Response to Reclamation Permit Application Consideration

DATE: February 15, 2023

RE: **Sunset Industrial Pit, M-2023-001**

Nearby Lined Pits

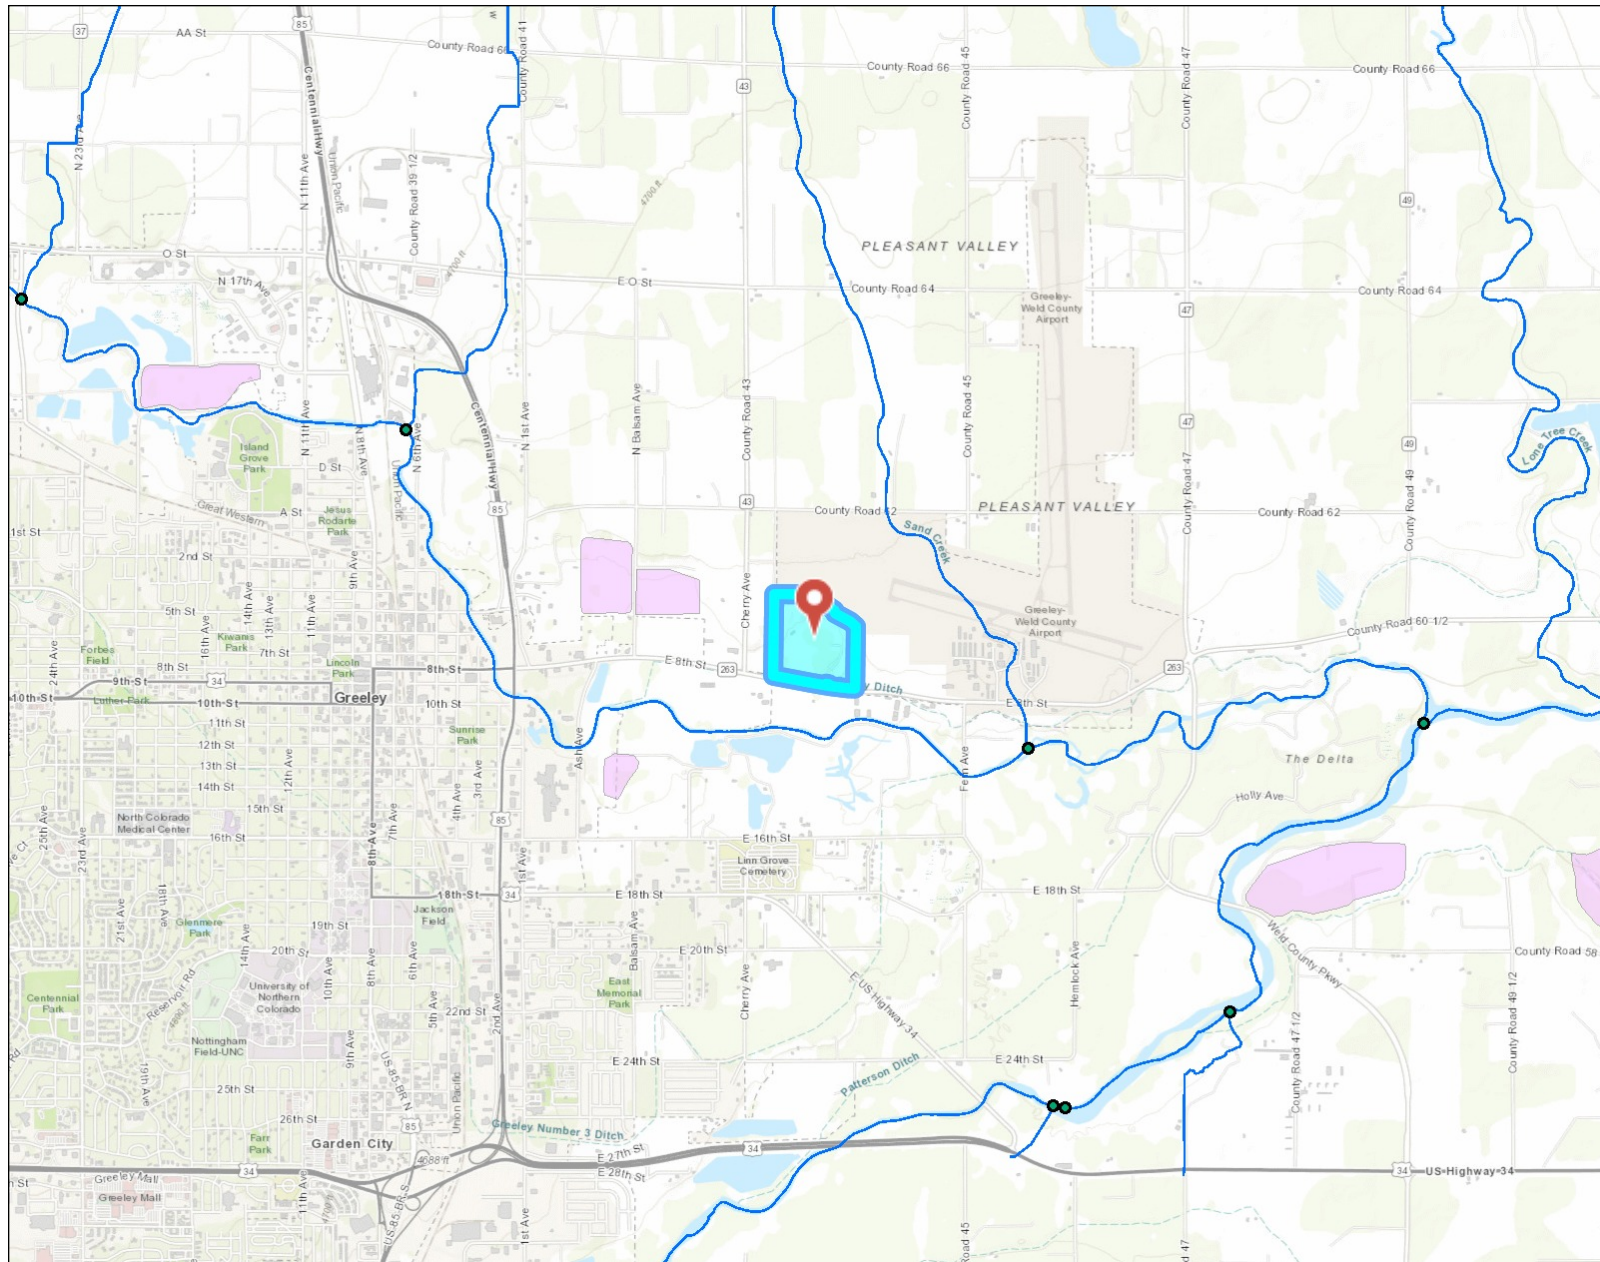
Additionally in certain areas of the South Platte River Basin, SEO staff have observed groundwater problems that appear to be related to the lining of gravel pits located near streams, and in particular, these problems occur when multiple liners are located adjacent to each other. This office requests that DRMS consider the siting and design of lined gravel pits to ensure that they will not individually, or cumulatively, result in impacts to the timing and quantity of groundwater flow from upgradient locations back to the stream system. In addition to impacts to property, such as flooding upgradient and reduced water levels downgradient of the liner, there are decrees of the court that specify the timing, quantity, and amount of water depleted from the streams by wells and accreted to the stream through recharge operations. The installation of a gravel pit liner should not result in changes to the timing, location, and amount of such groundwater flow. In the design and construction of the liner, the applicant and DRMS should consider whether drainage structures are needed to allow water to flow back to the stream and to prevent water mounding behind the liner. The attached map shows the location of lined pits according to our records in the vicinity of this proposed pit.
